**Sent:** 7/06/2021 10:38:27 AM  
**Subject:** DA 2021/0398  
**Attachments:** Submission No. 26 Update - 07.06.2021.pdf;

**RE: Development Application - DA2021/0398**  
**90 Lawrence Street Freshwater**  
**Objections to Proposed Development – Secondary Dwelling**

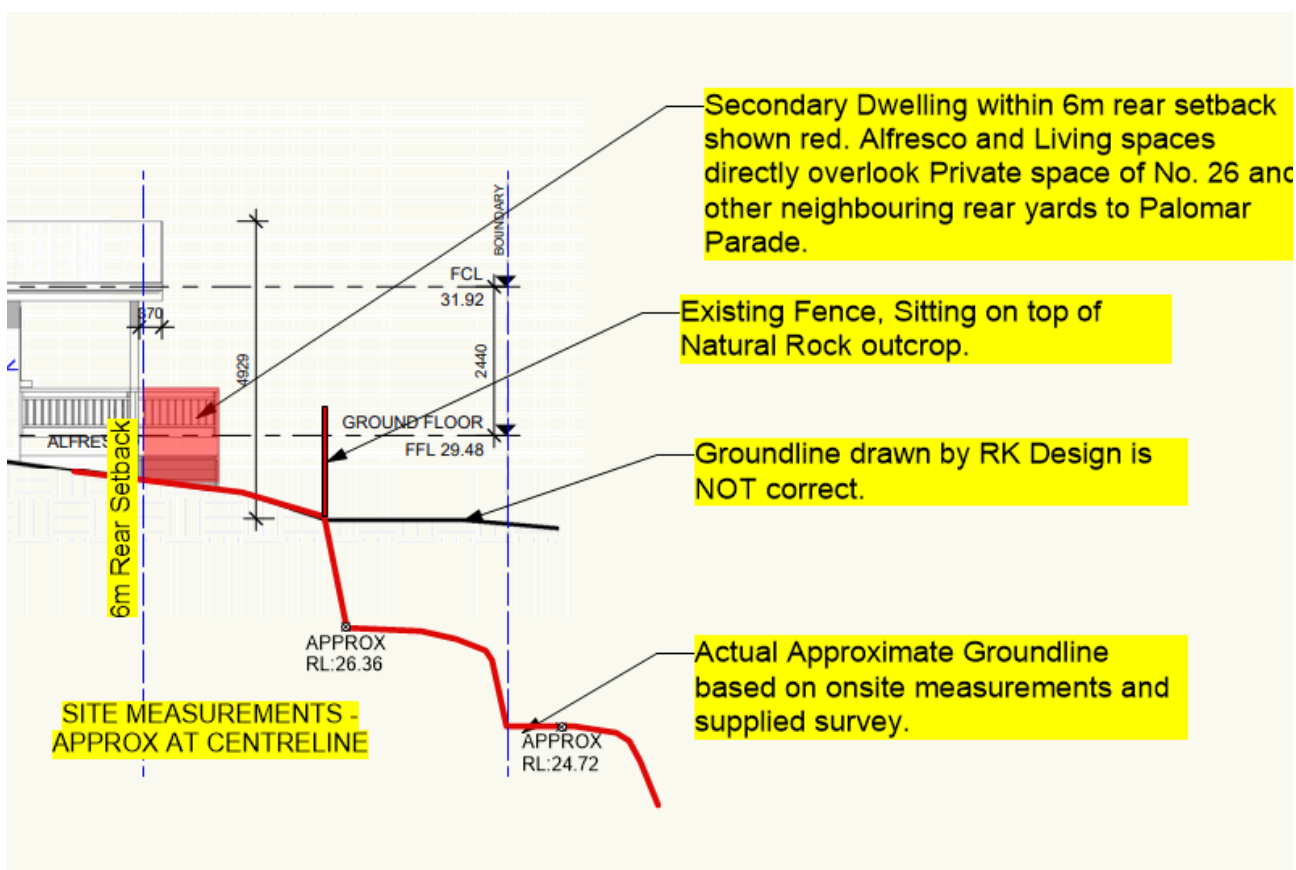
8. The proposal at No.90 proposes to remove 3 substantial trees at the rear boundary which currently provide visual separation and privacy to No.26. These also form part of the natural dominant landscape of rock formations and native trees with smaller native vegetation under. **we understand that this has been addressed with an arborist report – however the landscape referral proposes the planting of 3 new trees close to the fence line – We would like further information about this, as it refers to the southern fence line. Does this refer to the existing fence line or the boundary line. Noting that the area directly behind the existing fence line is steeply sloping and would not**

support planting – it would require a very large boundary wall retaining structure. Could we please request additional information.

See excerpt above from drawings submitted by RK Designs of proposed section – the ground line is still inaccurate and does not show the ground line.
